Subject: Cantilever lift rope pick up tube

Enclosed:
Technical memo TM037

Cantilever Sling 2:1 Hydraulic

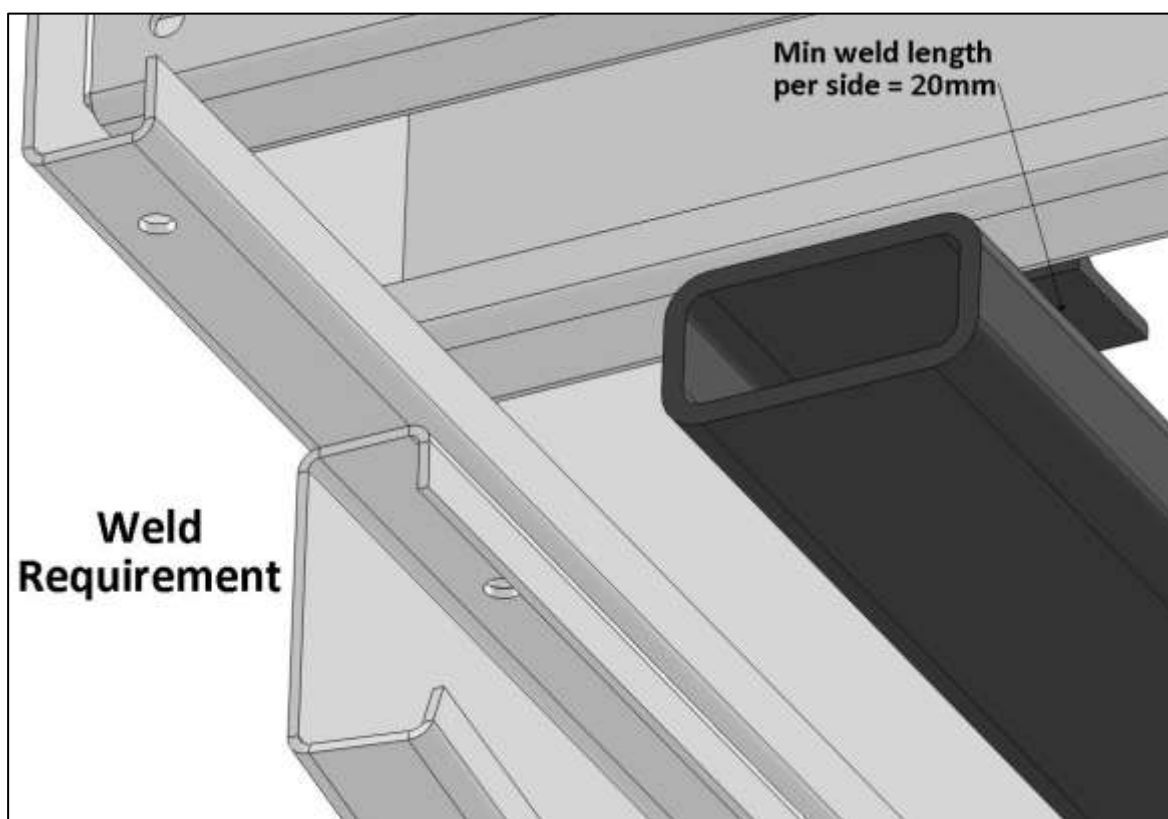
A problem has been identified with the rope pick up assembly on Oakland Excelsior 2:1 hydraulic lifts. Some batches of these have been manufactured with insufficient weld to the connecting cleat. This is shown in the diagram below.

Check the weld length in the area indicated. If the length of weld down each side of the cleat exceeds 20mm no action need be taken. In the event that the weld length is less than 20mm the Rope pick-up tube should be fastened to the folded cross plate by drilling and fixing using Grade 8.8 M12x40 Bolts as shown
